The disk brake system was given an update for the MK3 and MK4 XT912 series aircraft, we're pleased to announce these are now available for our disk brake fitted Edge XT582 and Edge XT912 series aircraft.

PART No: 113324 - BRAKE RESERVOIR & BRAIDED LINES KIT \$385.91 inc GST

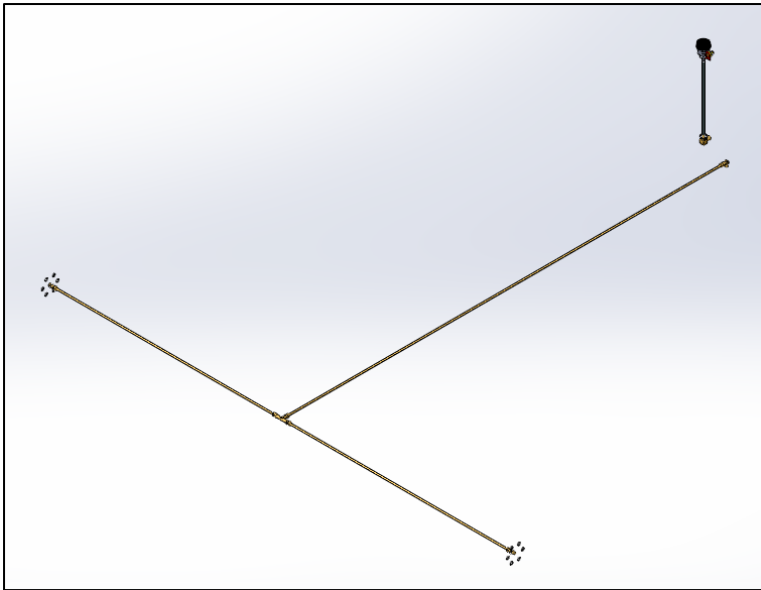
A motorcycle-style brake reservoir is mounted at the top left of the front wheel fork, a hose and fittings plumbing it into the master cylinder. Maintenance including level checking, top-up and bleeding of the system is simpler.

Braided brake lines have been introduced providing a more precise pedal feel and improved stopping power. The included parts replace the existing jic fittings and nylon tube from the master cylinder to the rear wheel slaves.

PART No: 112989 - DISK BRAKE ROTOR 1050 STEEL 44746 REVD \$33.07 inc GST

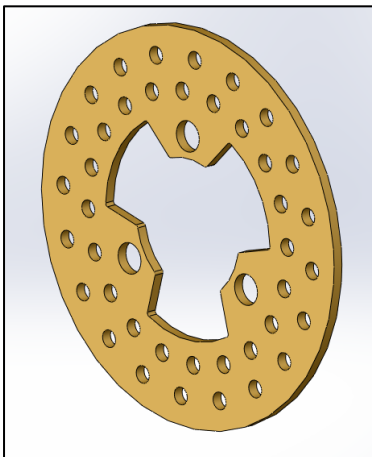
If you decide to install the braided lines we also strongly urge you to consider upgrading your disk rotors if you haven't already. We've beefed up the area around the bolt holes of the rotors in anticipation of increased load where they attach to the wheel and are a straight swap in swap out part.
